Technical Information

68/19 ENU 1901

Complaint - Coolant Pipe at Front of Cylinder Head Leaking: Installing coolant pipe with toothed ring (68/19)

Vehicle Type:	Cayenne (9YA)
Model Year:	As of 2018
Equipment:	3.0-liter 6-cylinder gasoline engine (engine code: DCBE)
Subject:	Coolant pipe at front of cylinder head

Coolant pipe at front of cylinder head

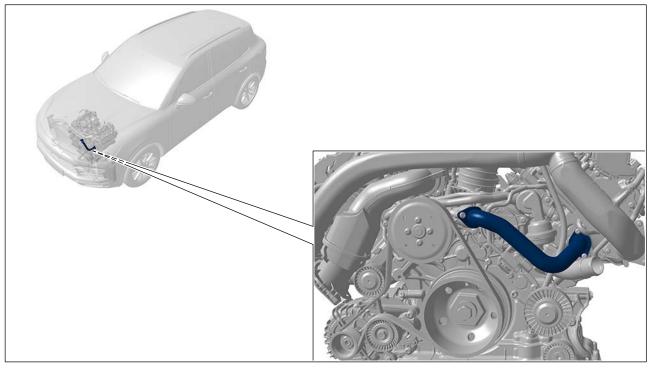
Information: Coolant pipe in cylinder head flange area leaking

Leak

Remedial In the event of a complaint, replace coolant pipe on cylinder head with a modified coolant pipe with Action: toothed ring (Part No. PAC121507).
